Access Compliance Report

Public Rights-of-Way

(Curb Ramps)

Intersection ID: 29419	Main Street: BRADSTREET_COMMONS_WY	Cross Street: DONET_TERRACE_DR	Location:	E
ADA ID: 6533056529E1	Ramp Type: Perpendicular	Initial Pass/Fail: Fail	Overall Compliance: No	Severity Score: 10
Codes/Mitigation Info/Possible Solution		Field Measurements/Component Compliance

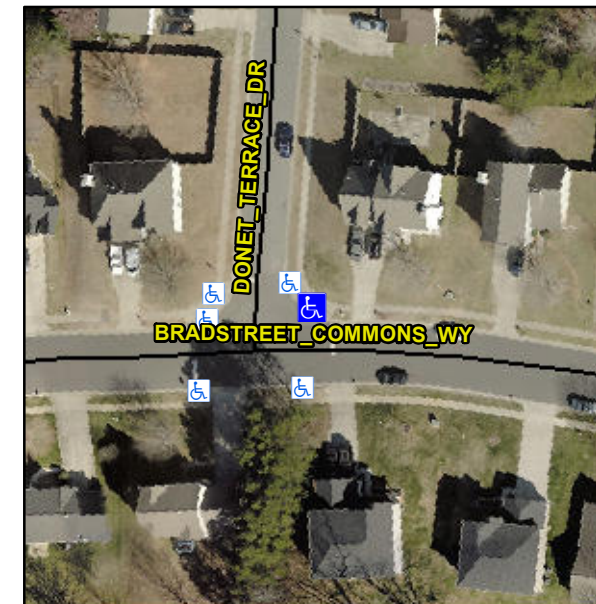
Not Found, R304.5.1

Compliance	Description	Data	Compliance	Description	Data
N/A	Ramp Length (in)	48.0	Yes	Ramp Slope (%)	7.1
No	Ramp Width (in)	47.0	Yes	Ramp XSlope (%)	4.1
N/A	Flare Type LT	N/A	N/A	Flare Type RT	N/A
N/A	Flare Slope LT (%)	N/A	N/A	Flare Slope RT (%)	N/A
N/A	Flare Traversable LT?	N/A	N/A	Flare Traversable RT?	N/A
N/A	Landing Length (in)	N/A	N/A	DWS Provided?	N/A
N/A	Landing Width (in)	N/A	N/A	DWS Contrast?	N/A
N/A	Landing Slope (%)	N/A	N/A	DWS Length (in)	N/A
N/A	Landing X Slope (%)	N/A	N/A	DWS Full Width?	N/A
N/A	Landing Curb? (Y/N)	N/A	N/A	DWS Offset (in)	N/A
N/A	Shared Landing?	N/A			
N/A	Gutter Ponding?	N/A	N/A	Gutter Slope (%)	N/A
N/A	Gutter Lip Ht (in)	N/A	N/A	Gutter X Slope (%)	N/A
N/A	Painted X Walk1?	No	N/A	Painted X Walk2?	N/A
	X Walk 1 Direction	To S		X Walk 2 Direction	N/A
N/A	X Walk 1 Width (in)	N/A	N/A	X Walk 2 Width (in)	N/A
	X Walk 1 Slope (%)	2.8		X Walk 2 Slope (%)	N/A
	X Walk 1 X Slope (%)	6.7		X Walk 2 X Slope (%)	N/A

N/A	Ramp inside XWalk1?	N/A	N/A	Ramp inside XWalk2?	N/A
	Road Slope (%)	N/A	N/A	Clear Space?	N/A
	Road X Slope (%)	N/A	N/A	Clear Space to XWalk (in)	N/A
N/A	Any Obstructions?	N/A	N/A	Storm Grate/Utility Hazard?	N/A
	Obstruction Type			Storm Grate/Utility Type	
		N/A			N/A
			Yes	Surface Condition? (G/P)	Good

Remove & Replace Entire Ramp.
